**Major Projects
Council Submission
Project Mars Data Centre (SSD-82052708) (Lane Cove)**

Environmental Impact Statement Response for the Project Mars Data Centre at 12 Mars Road, Lane Cove West.

Figure 2: Non-compliant portions located towards sensitive receivers (Source: Council Planner)

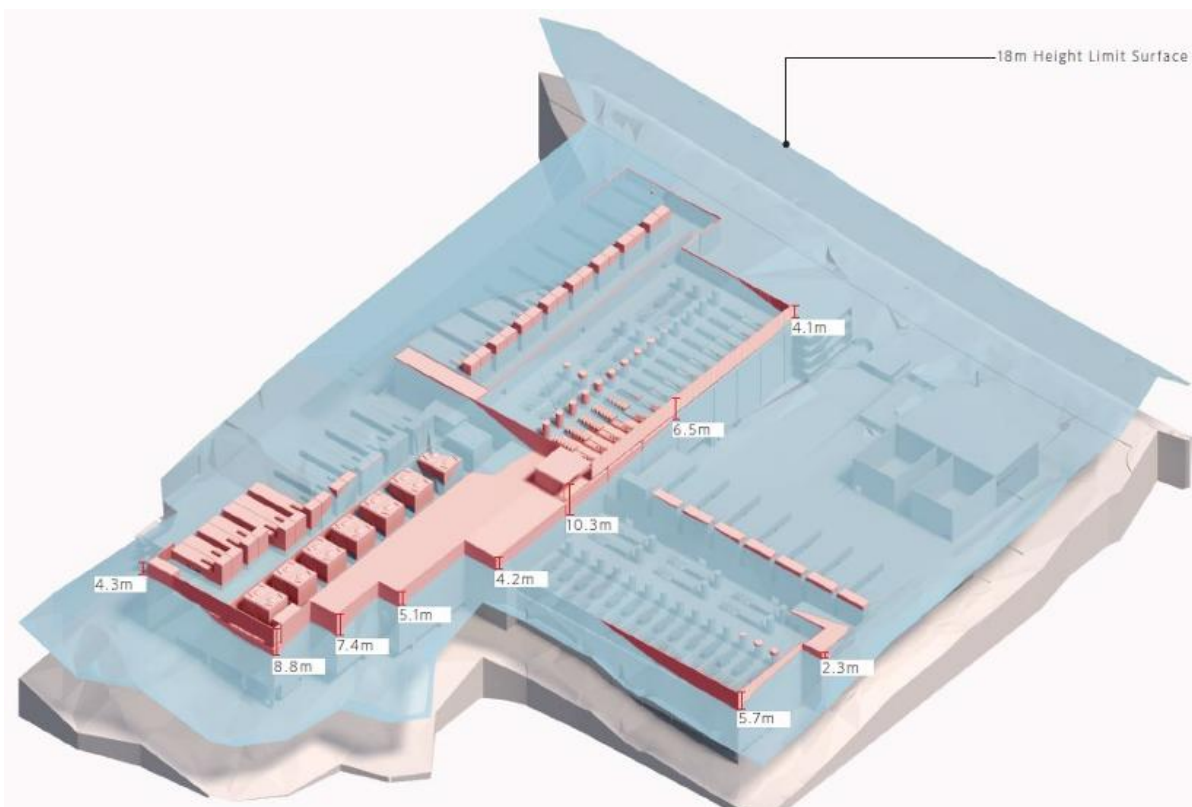
The proposed development includes a height which significantly breaches the maximum permissible height standard, as shown in **Figure 2** below. A Clause 4.6 request to breach this development standard has been provided and is not supported by Council. The proposed development fails to satisfy the relevant tests required for assessing the proposed breach as outlined below.

The non-compliant portions of the building result in adverse overshadowing impacts. This includes unnecessary adverse impacts on existing landscaped areas on site (significant trees to be retained), the adjoining bushland areas and public recreation areas such as the skate park. The increased shadows detrimentally impact the viability of existing foliage which is extensively relied upon throughout the Visual Impact Statement and this Clause 4.6 Request. Any additional shadowing generated by the non-compliant area of the development is considered to be unreasonable, unnecessary and not warranted in this instance. **Figure 3** illustrates the significant increase in overshadowing resulting from the non-compliant areas in purple (located above the Bushland area). The Clause 4.6 request should not be supported as the proposal fails to satisfy objective (a).

The non-compliant portions of the building would be visually prominent to the adjoining zones, which has not been adequately reported in the Visual Impact Statement. The non-compliant areas which result in these adverse impacts have been located towards the zonal transition and most sensitive receivers being the Bushland area and residential developments. The Clause 4.6 states that *the built form along the Mars Road frontage will fully comply with the existing height control*. The proposed development includes non-compliant breaches along the frontage areas, as illustrated in **Figure 2** below. The Clause 4.6 request should not be supported as the proposal fails to satisfy objective (b).

Figure 4: Location of view points for the VIA (Source: VIA)

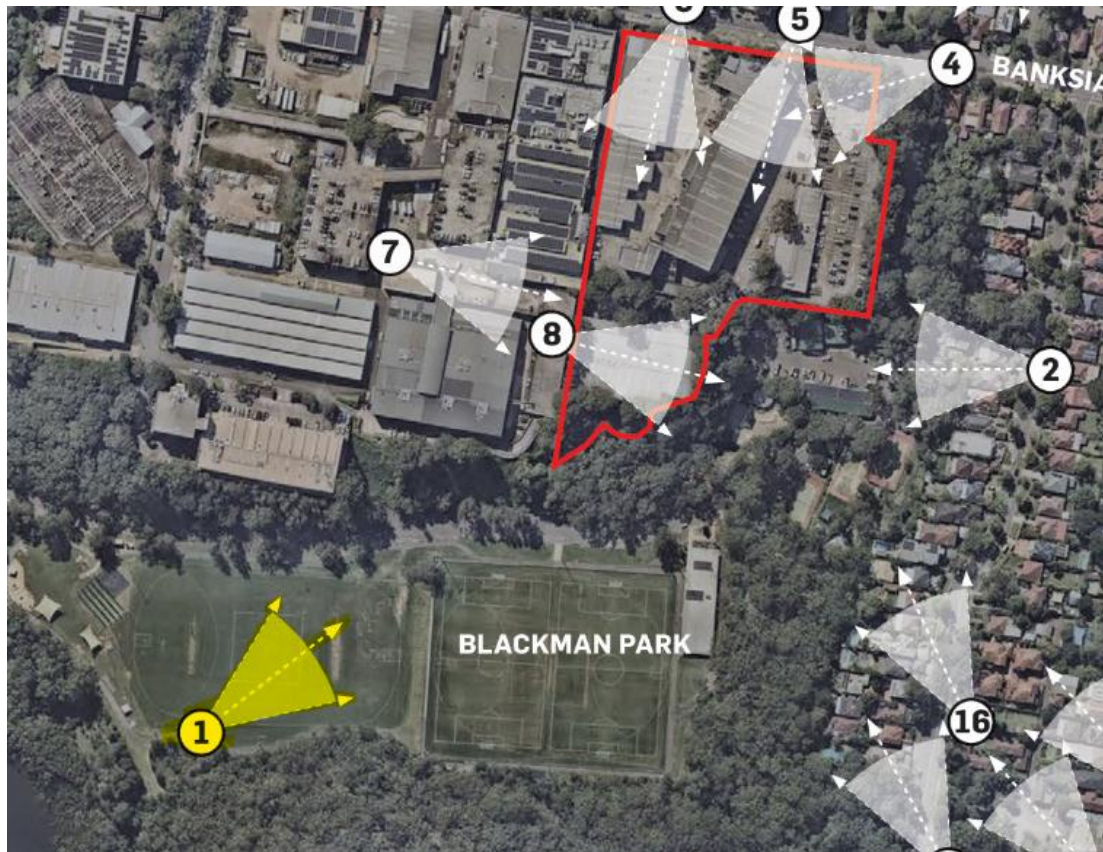
Seven public domain photomontages are provided in order to assess the visual impacts. The VIA has omitted photomontages from identified locations which present a development with reduced impacts, refer to location 4 on page 10 of the VIA. The photomontages also provide an inaccurate consideration on view impacts with particular reference to VP2 and VP3 on page 17 of the VIA.

Blackman Park is one of Council's premier sporting precincts and the VIA merely provides analysis from 1 distant oblique angle, refer to **Figure 4 and 5** below. Council has listed the Public Areas which would be subject to significant visual impacts and are required to be considered at a minimum, refer to **Figures 6 to 22c** below. The existing structures have been highlighted in white, and it is important to consider that the proposed development is up to 15m taller than the existing building which is already this height in some instances. Photomontages should be proposed for these areas and should include an outline of the existing development for context of the impacts to ensure a complete assessment on visual impacts.

Figure 22c: 64 Wood Street, existing structures shown in white. (Source: Council Planner)

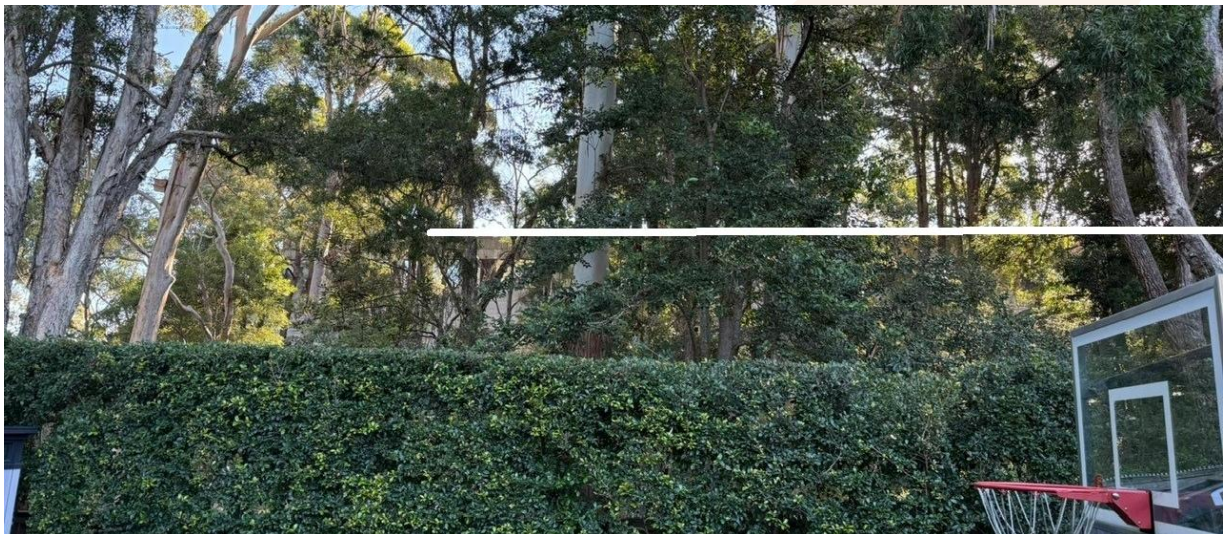
An assessment and photomontage has not been provided for the following key public recreation areas and residential dwellings which are subject to adverse visual impacts:

Figure 23: Riparian Land Mapped in Green and adjoining the site (Source: ePlanning Spatial Viewer)

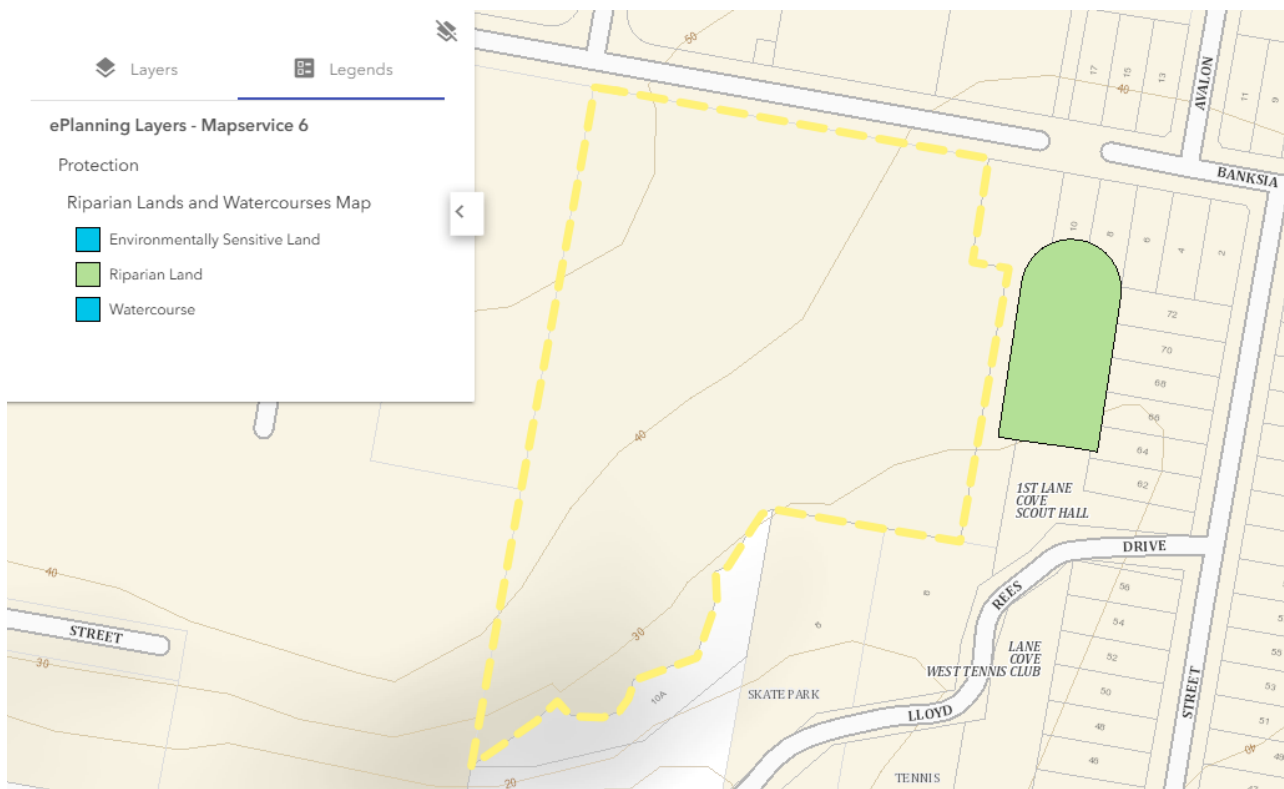
Section 6.3 Riparian Land of the Lane Cove LEP 2009 seeks to ensure that development does not adversely impact on riparian land, as identified in **Figure 23** below, and requires that:

The proposed development should not be supported as the consent authority cannot be satisfied that the impacts of the development on the Riparian land has been adequately considered. The reports provided by the Applicant confirm that the detailed design and any of the mitigation measures required have not been considered.

Figure 24: Section through the site with existing ground level in dashed red and levels of excavation depicted in blue (Source: Architectural Plans)

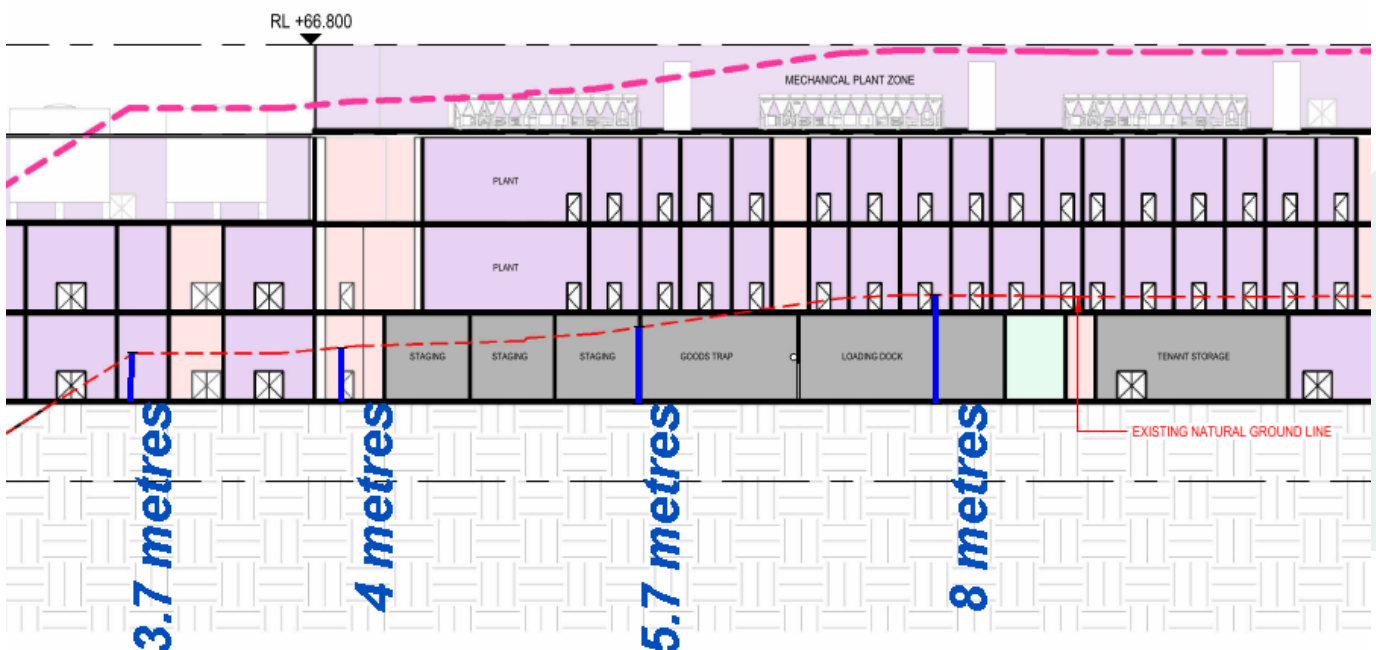
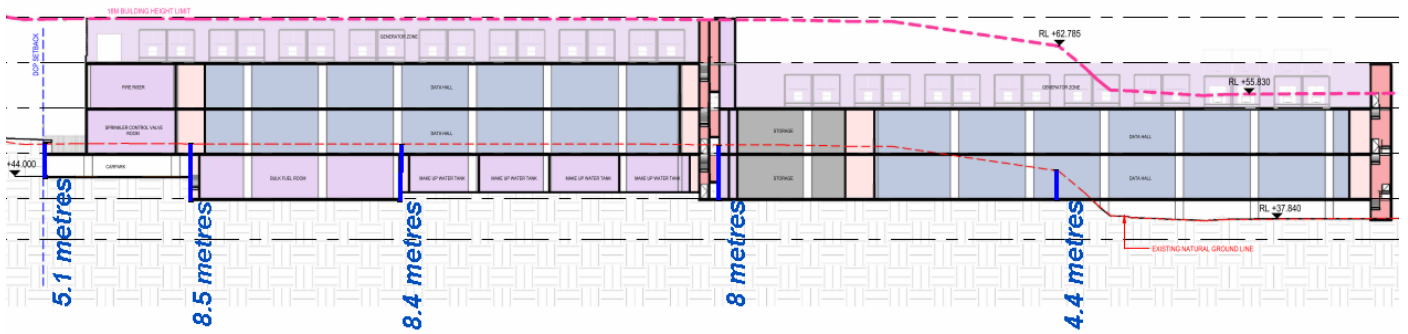
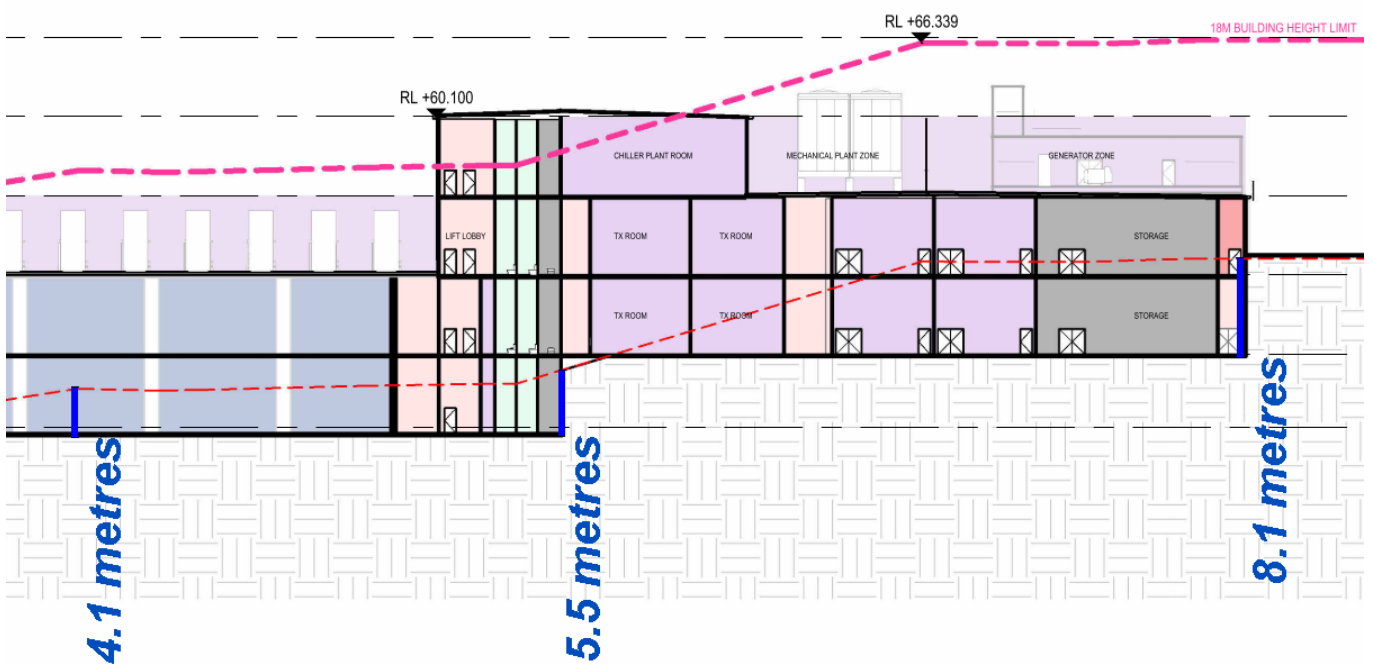
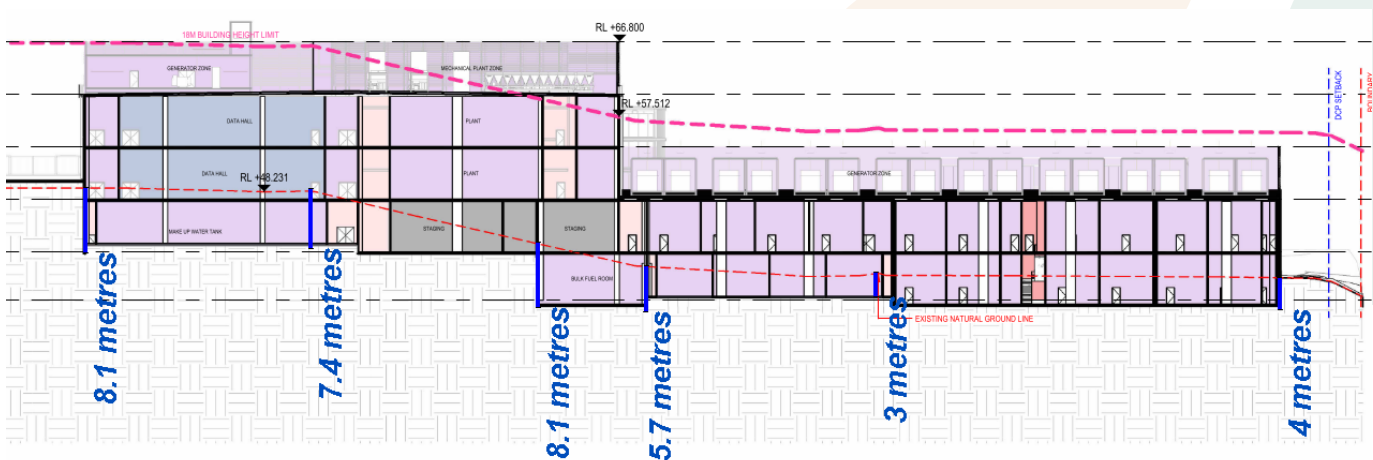
The proposed development includes excavation well beyond what is considered reasonable for the industrial zone. No developments within the industrial zone provide excavation beyond 8m. This is of particular concern where sensitive Bushland and Riparian areas are located adjoining (and naturally down slope) of the subject site, which have not been considered as discussed throughout this response. The proposed excavation is not provided in small sections to address site topography, but expands the full width of the development, as shown **Figures 24 to 27** below.

Figure 28: Solar diagrams provided prior to lodgement for the consideration on the Nursery's productivity (Source: Applicant.

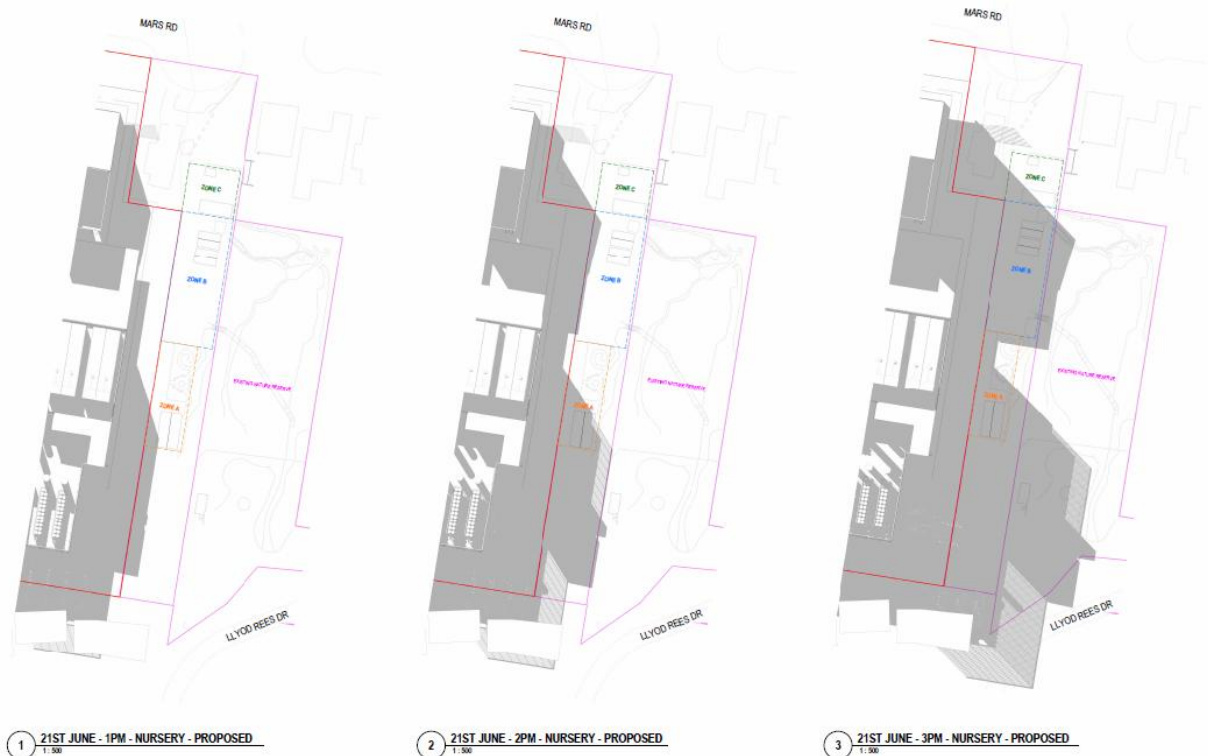
The Applicant has commenced VPA discussion with Council's Manager of Commercial Operations regarding upgrading the facilities of the nursery. Extensive Shadow diagrams dated 25 / 09 / 2025 were provided to Council to confirm that the growing windows and operation / efficiency of the Nursery would not be adversely impacted in terms of solar access, refer to **Figure 28** below. The finding was in terms of the solar window provided to the plants (beyond what is originally considered for solar access between 9am – 3pm) that whilst there would be increased impacts to Zone A, there would be increased solar access within Zone B and Zone C. This is resultant from the

Council would not accept any reduction in the productivity of the Nursery and any amendments which remove this gap and associated increased solar window would not be supported.

Figure 29: Shadow diagrams which accompany the EIS (Source: Architectural Plans)

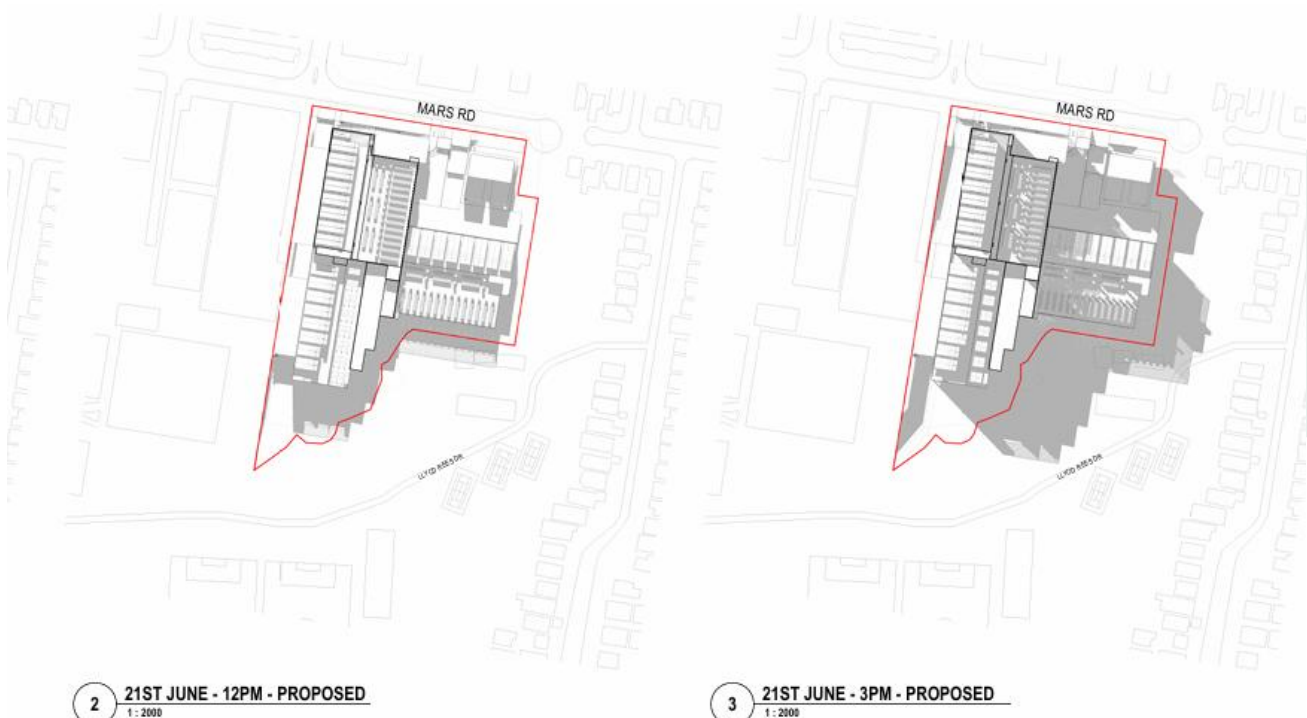
solar gap provided between the data hall and substation. This design has been retained and as confirmed by the shadow diagrams provided for the SSDA, refer to **Figure 29** below.

Figure 30: Site is adjacent to bushland (C2) on eastern and southern boundaries (Source: LEP Mapping)

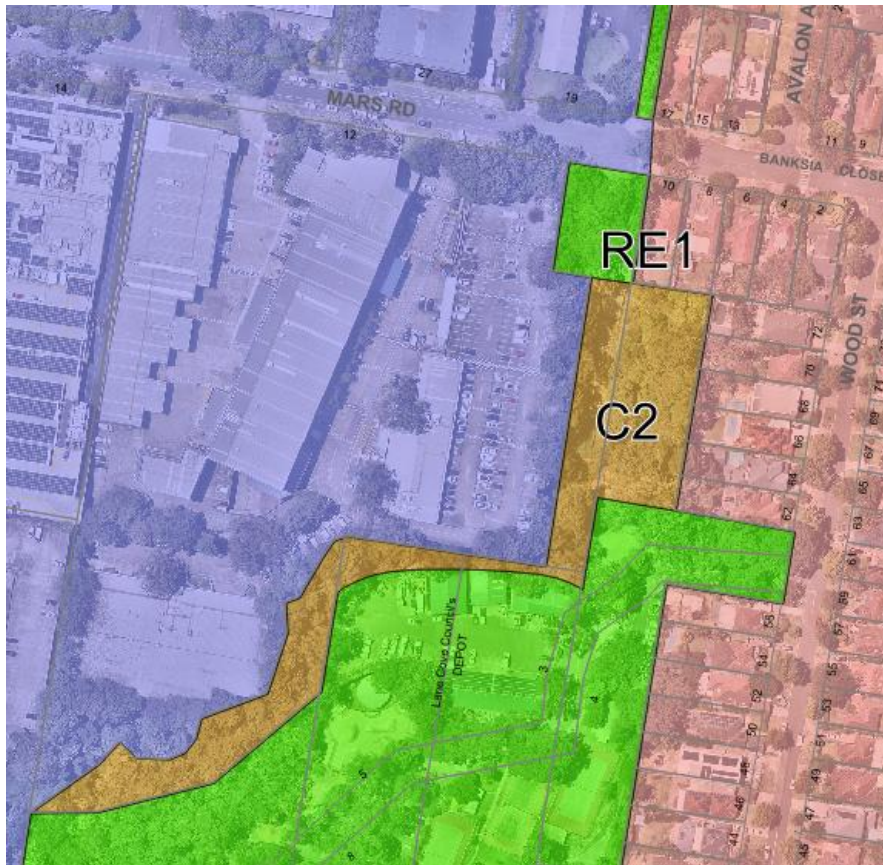
The property adjoins C2 Environmental Conservation zoned land (Bushland and Council's Community Nursery) to the east and south of the site, refer to **Figure 30** below. The vegetation community consists of Coastal Enriched Sandstone Sheltered Forest.
